**ATTACHMENT 9**

**AGENCY RESPONSES**

### **REQUEST FOR FURTHER INFORMATION ON DEVELOPMENT PLAN**

## MONASH VIEWS DEVELOPMENT PLAN

MONASH VIEWS  
DEVELOPMENT

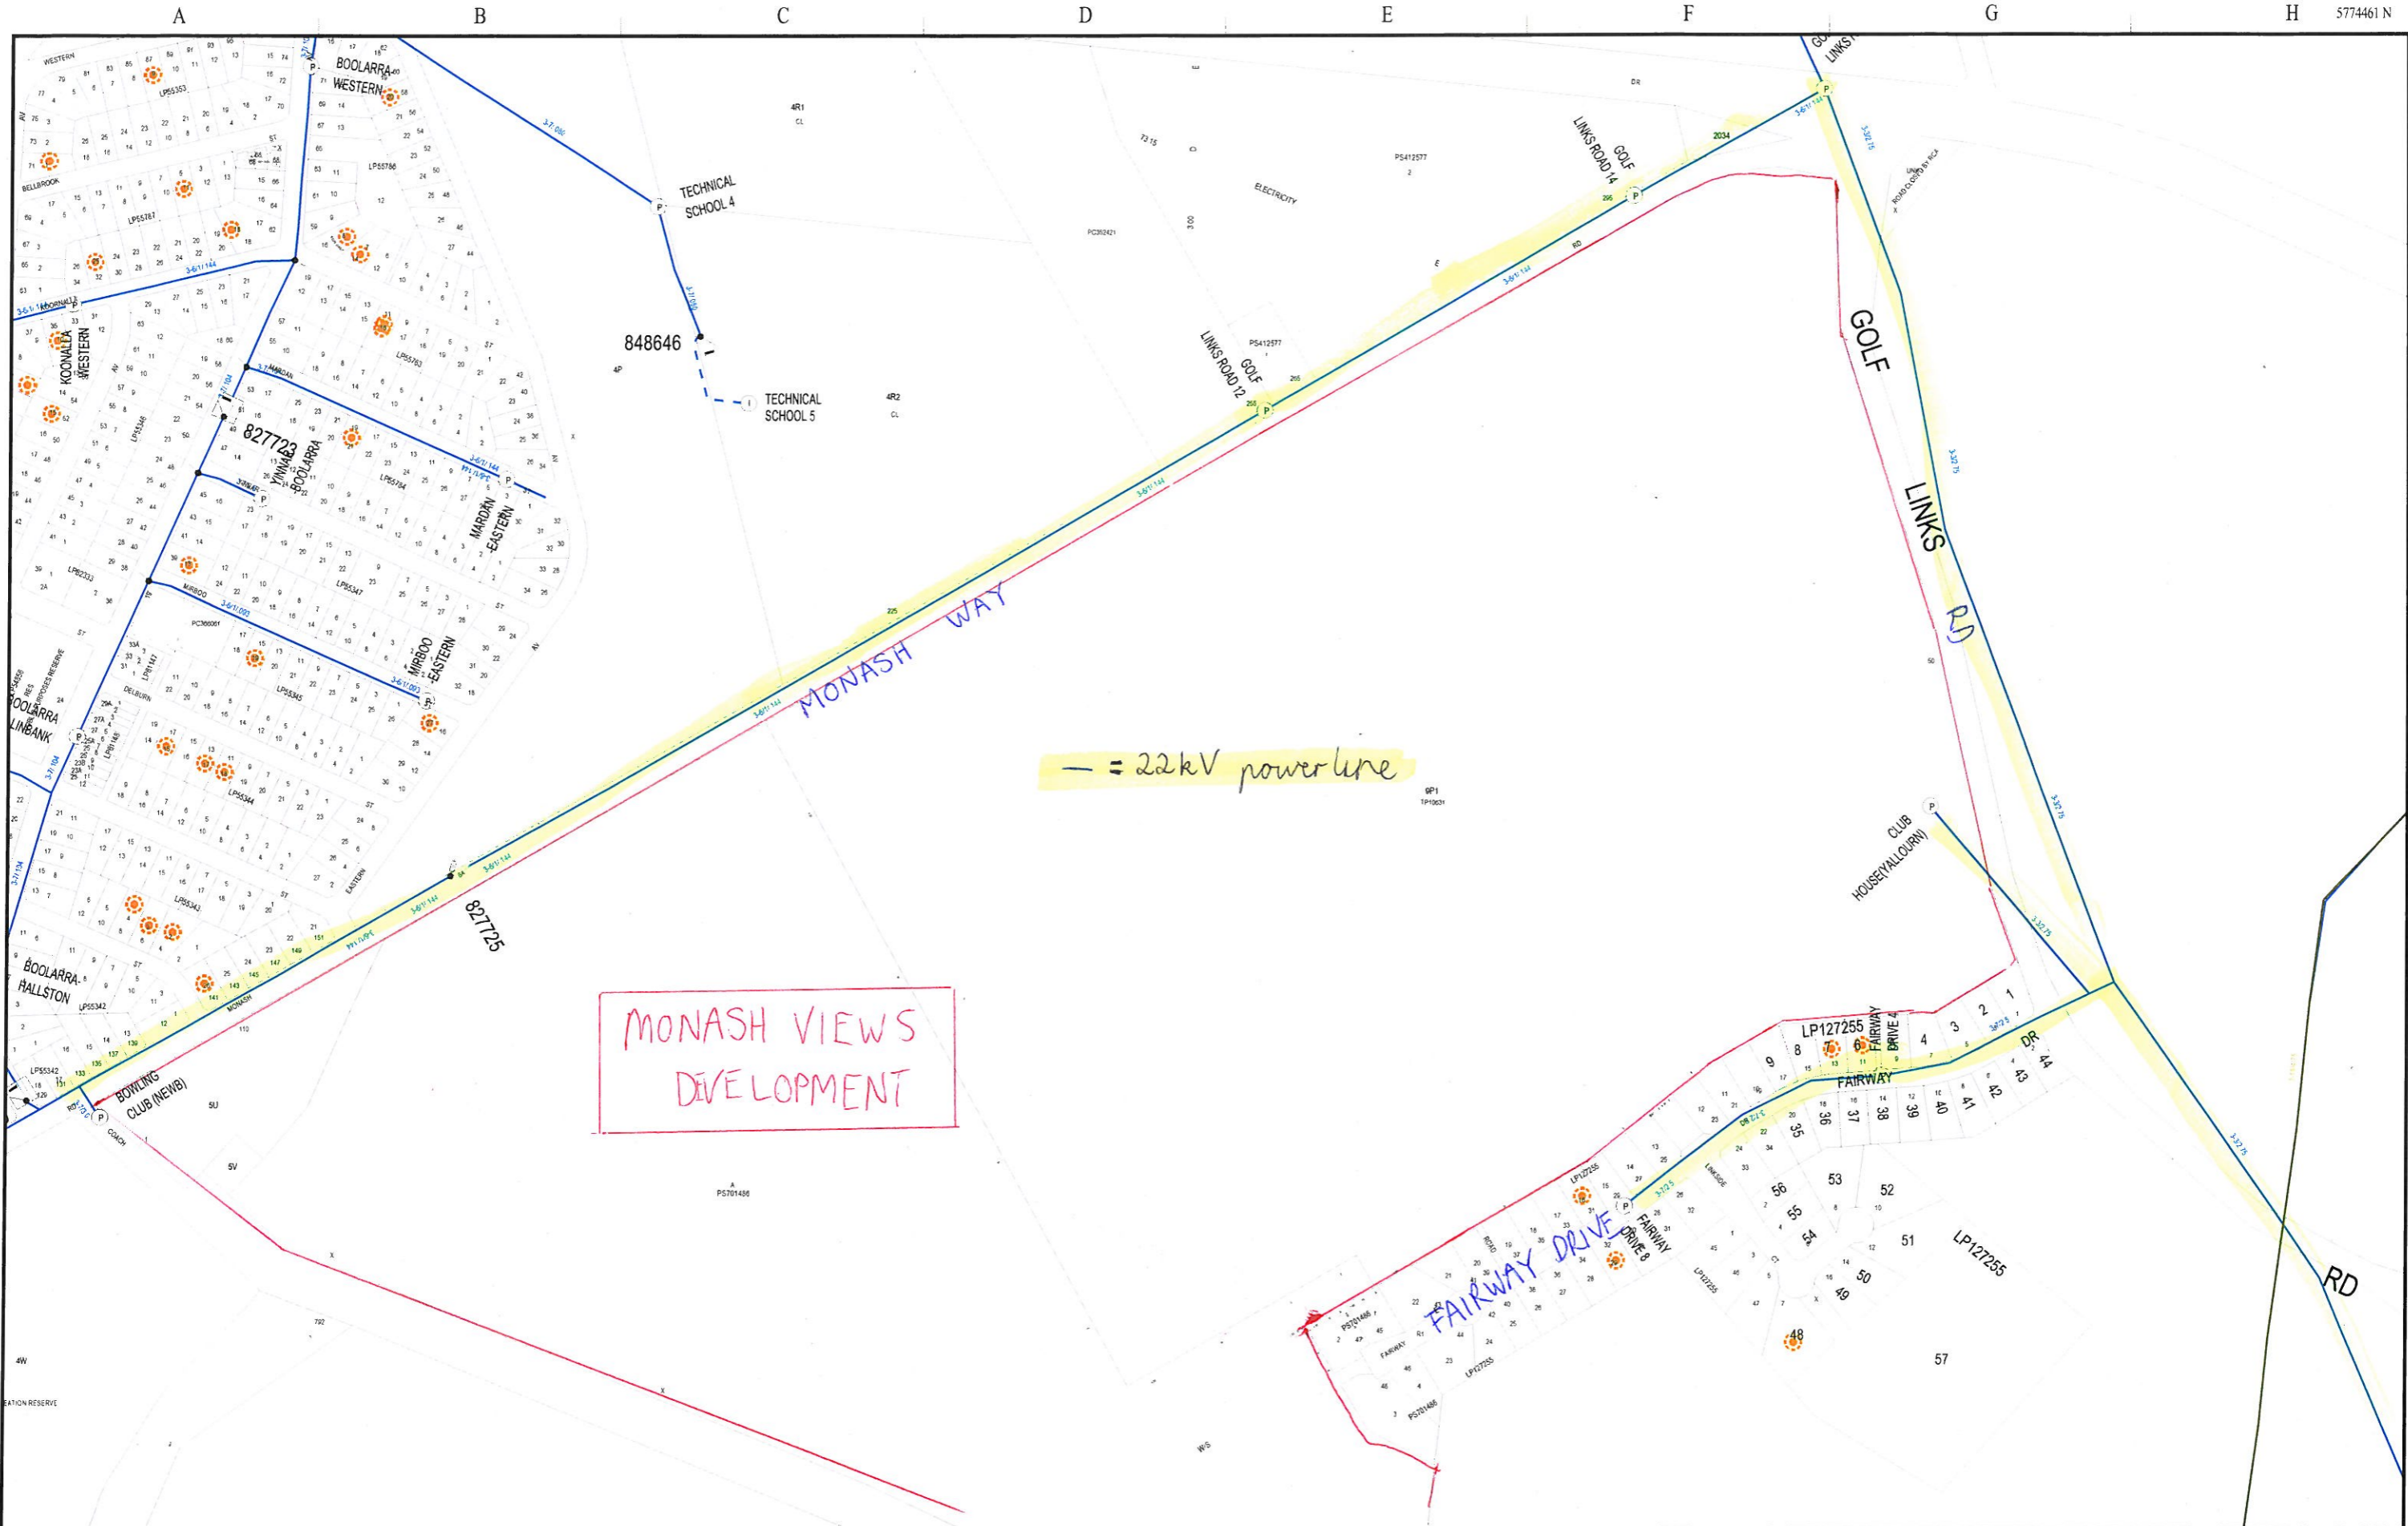
- There are 22kV overhead powerlines located on the eastern and northern side of the development (Monash Way & Golf Links Rd). These existing powerlines will need to be augmented into the estate layout proposal. All costs associated with any design or construction change would be borne by the customer/developer.

- I have attached an AMFM plot showing our 22kV assets in and around the proposed development.
- Based on advice from our Network Planner – The 22kV line running along the boundary of the development will not be able to accommodate the development. This will potentially require reconductoring of the line and a protection review. Again, the customer/developer will need to contribute towards the costs of these works. We will need more information to be able to make a detailed assessment of the works required to accommodate this subdivision. This information can be provided at the time of application.
